Product Change Notice (PCN)

PCN Number: PCN-0454731R-01

Product(s) Affected: SJ-2504A-SMT-TR

PREVIOUS CUI DEVICES DETAIL / IMAGE	NEW CUI DEVICES DETAIL / IMAGE

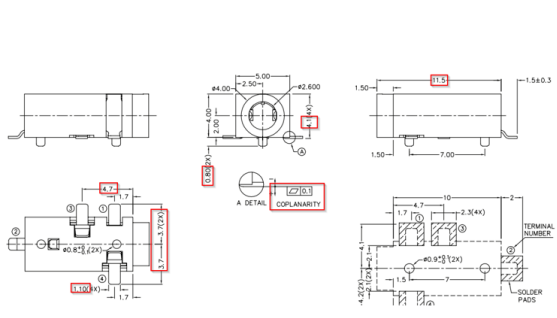
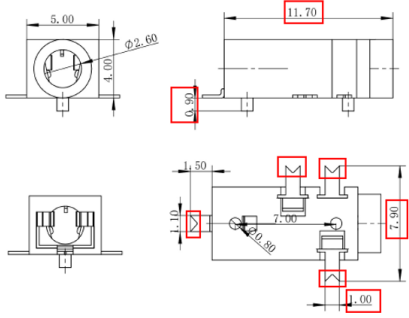
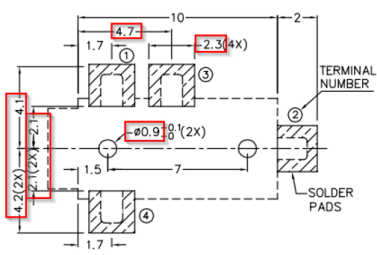
Description of Change: mechanical, material, packaging, and soldering differences as shown below:

<p style="text-align: center;">Recommended PCB Layout Top View</p>	 <p style="text-align: center;">Recommended PCB Layout Top View</p>																																				
<table border="1"> <thead> <tr> <th></th> <th>MATERIAL</th> <th>PLATING</th> </tr> </thead> <tbody> <tr> <td>terminal 1</td> <td>copper alloy</td> <td>silver</td> </tr> <tr> <td>terminal 2</td> <td>copper alloy</td> <td>silver</td> </tr> <tr> <td>terminal 3</td> <td>copper alloy</td> <td>silver</td> </tr> <tr> <td>terminal 4</td> <td>copper alloy</td> <td>silver</td> </tr> <tr> <td>plastic</td> <td>PA10T</td> <td></td> </tr> </tbody> </table>		MATERIAL	PLATING	terminal 1	copper alloy	silver	terminal 2	copper alloy	silver	terminal 3	copper alloy	silver	terminal 4	copper alloy	silver	plastic	PA10T		<table border="1"> <thead> <tr> <th>DESCRIPTION</th> <th>MATERIAL</th> <th>PLATING/COLOR</th> </tr> </thead> <tbody> <tr> <td>terminal 1</td> <td>phosphorus bronze</td> <td>silver</td> </tr> <tr> <td>terminal 2</td> <td>phosphorus bronze</td> <td>silver</td> </tr> <tr> <td>terminal 3</td> <td>phosphorus bronze</td> <td>silver</td> </tr> <tr> <td>terminal 4</td> <td>phosphorus bronze</td> <td>silver</td> </tr> <tr> <td>housing</td> <td>PPA [UL94V-0]</td> <td>black</td> </tr> </tbody> </table>	DESCRIPTION	MATERIAL	PLATING/COLOR	terminal 1	phosphorus bronze	silver	terminal 2	phosphorus bronze	silver	terminal 3	phosphorus bronze	silver	terminal 4	phosphorus bronze	silver	housing	PPA [UL94V-0]	black

MATERIAL	PLATING																																			
terminal 1	copper alloy	silver																																			
terminal 2	copper alloy	silver																																			
terminal 3	copper alloy	silver																																			
terminal 4	copper alloy	silver																																			
plastic	PA10T																																				
DESCRIPTION	MATERIAL	PLATING/COLOR																																			
terminal 1	phosphorus bronze	silver																																			
terminal 2	phosphorus bronze	silver																																			
terminal 3	phosphorus bronze	silver																																			
terminal 4	phosphorus bronze	silver																																			
housing	PPA [UL94V-0]	black

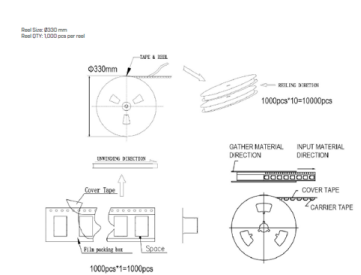
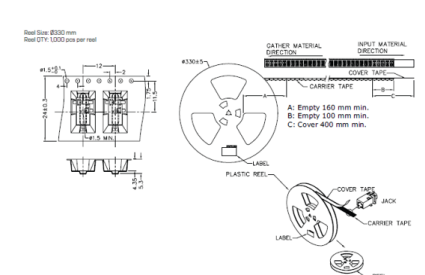
SOLDERABILITY				
parameter	conditions/description	min	typ	max units
reflow storage	at relative humidity <math>< 50\%</math>			400 °C
reflow soldering	see reflow profile	255	280	285 °C
drying conditions	parts in reel bake at 40°C ±5°C for 72 hours parts removed from reel bake at 40°C ±5°C for 10 hours

Notes:
 1. Must reflow solder within 72 hours from opening vacuum packaging at a temperature <math>< 50\%</math> relative humidity <math>< 50\%</math>
 2. When unloading from file by 172 hours.

SOLDERABILITY				
parameter	conditions/description	min	typ	max units
reflow storage	10-30°C, <math>< 70\%</math> humidity			
reflow soldering	see reflow profile	255	280	°C
drying conditions	parts in reel bake at 110°C for 4 hours parts removed from reel bake at 110°C for 4 hours

Notes:
 1. CuI Devices recommends to solder within 72 hours from opening vacuum packaging at a temperature <math>< 50\%</math> relative humidity <math>< 50\%</math>
 2. When unloading from file by 240 hours.
